November 2018 AcquiSuite/AcquiLite Firmware changes

Version **v02.18.1117** for A7810, A8810, A8812, and A8814.

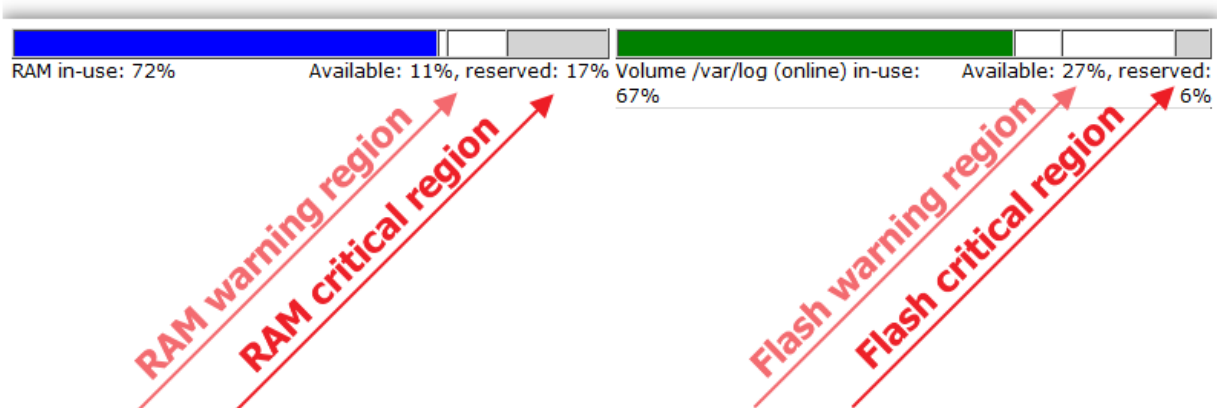
- To help customers gauge the effect on system RAM and Flash of particular configuration changes, we've added RAM and Flash usage bar-graphs, shown at the bottom of each page of the Web UI, to help users *visualize* the effect of their choices and changes. For example:

- **Each bar-graph will change to color red** when the resource enters the Warning or Critical region.
- **To use the new bar-graphs**, simply *notice* the effect on RAM or Flash as you add Devices or enable Features, and stay out of the **red** regions.
- The **Critical** regions of RAM and Flash usage (shown in gray on the bar-graphs as “**reserved: %**”)
